**CHARLOTTE - MECKLENBURG**  
**PLANNING COMMISSION**

**SUBJECT:** Administrative Approval for Petition No. 2000-76 Crosland Land Co.

**TECHNICAL  
DATA SHEET  
PETITION #00-76**

**HIGHWAY 521**  
**PLANTING PLAN**  
**PETITION #00-76**

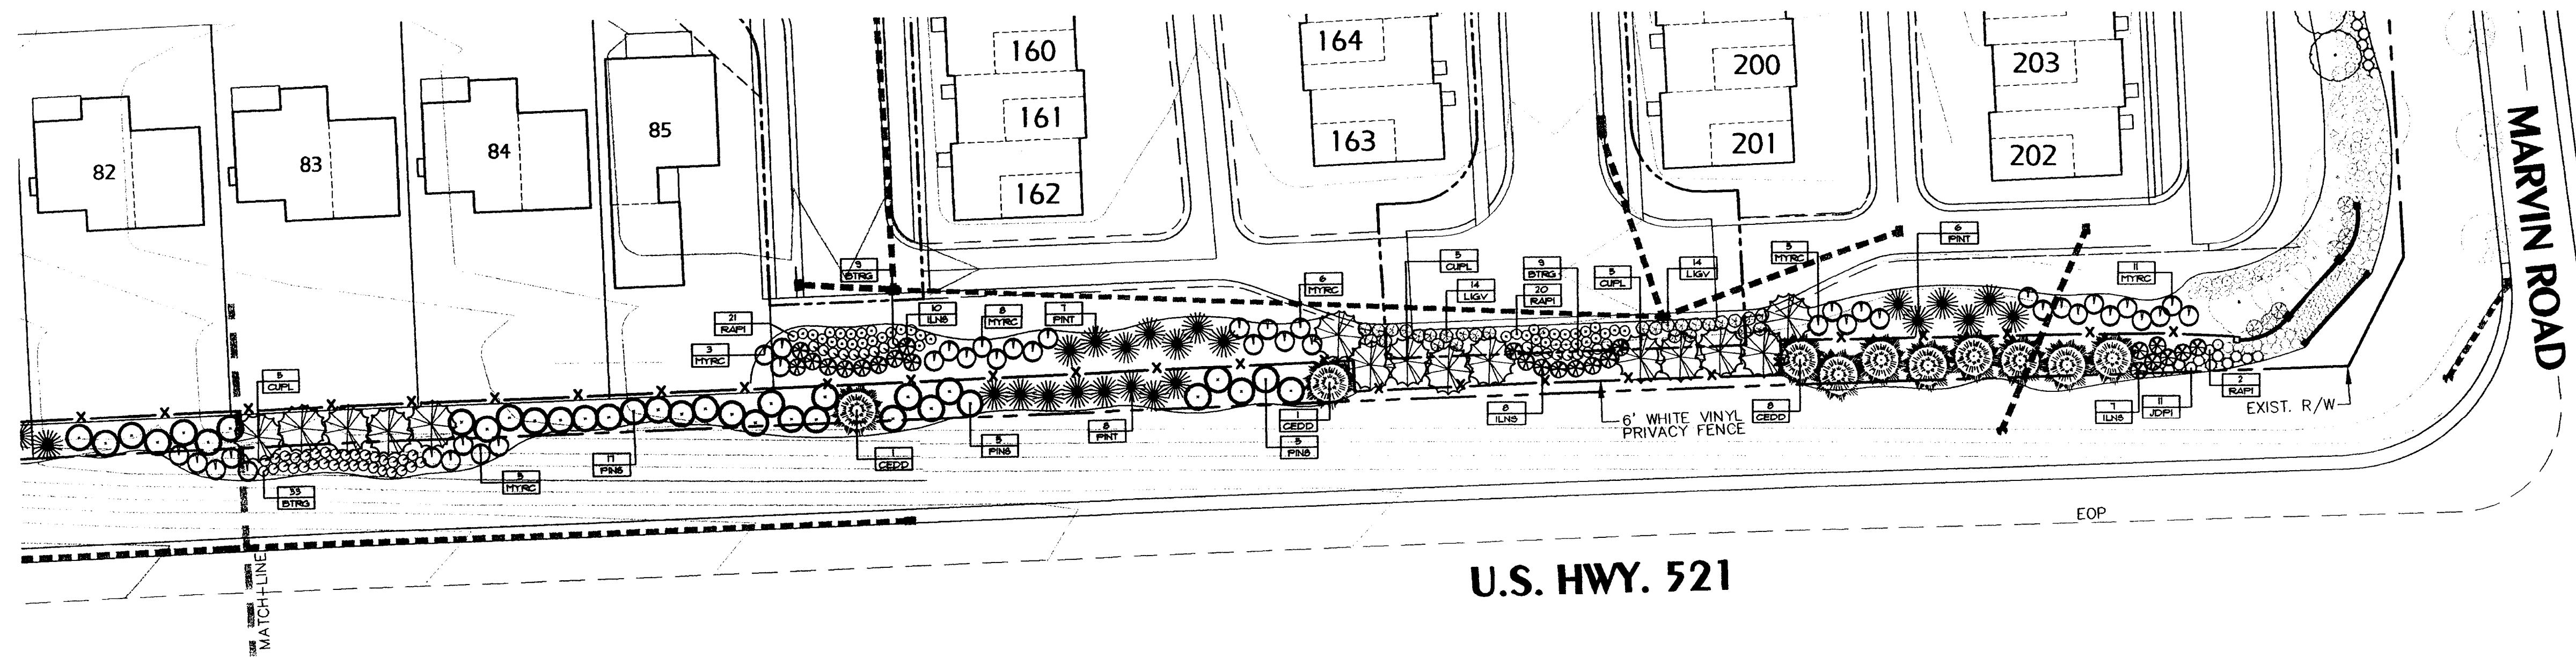
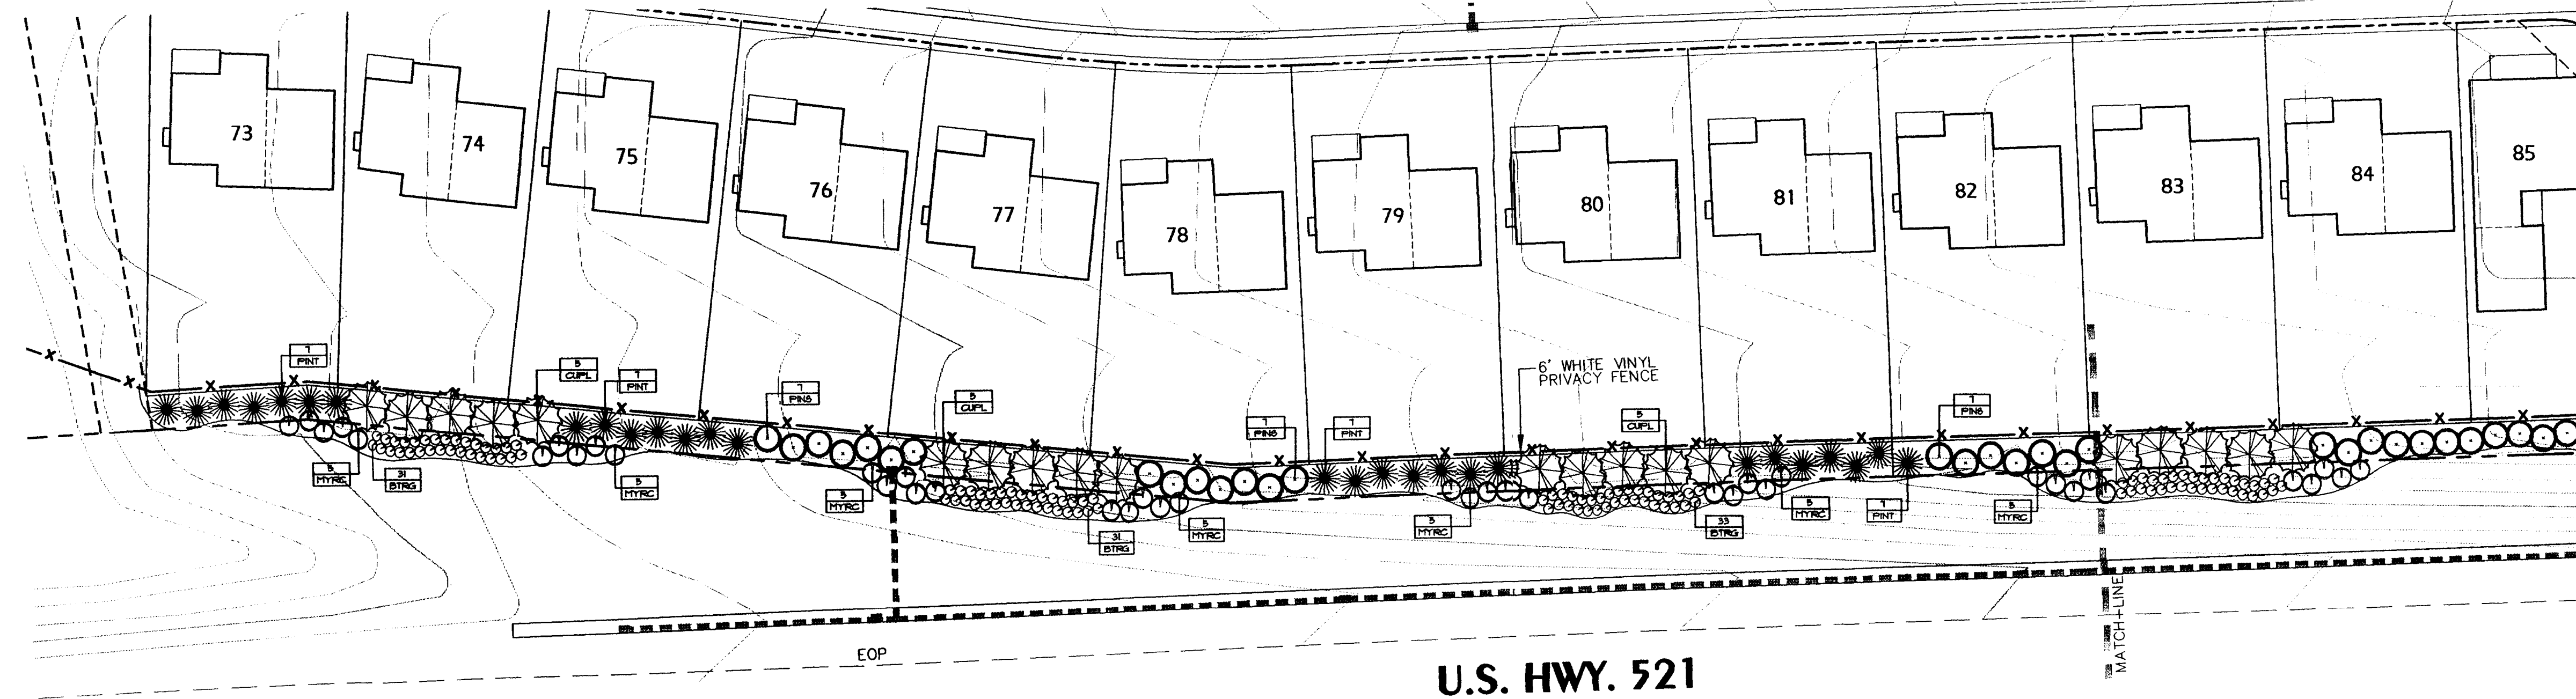
Attached is the revised plan for the above petition. The plan has been revised to change the treatment along US 521. Since these changes do not alter the intent of the development and meets the requirements of the Charlotte Zoning Ordinance Section 6.206(2) Alterations to Approval for minor changes, I am administratively approving this plan. Please use this plan when evaluating requests for building permits and certificates of occupancy.

1. Street trees shall be provided at a minimum of 50' O.C.
2. The Petitioner will provide landscaping along Highway 521 as shown on Highway 521 Planting Plan (Sheet 3 of 3).
3. The Petitioner commits to providing landscaping along Marvin Road to satisfy the minimum requirements of the City of Charlotte Tree Ordinance.
4. Street trees within street R.O.W.'s shall count toward the requirements of the City of Charlotte Tree Ordinance.
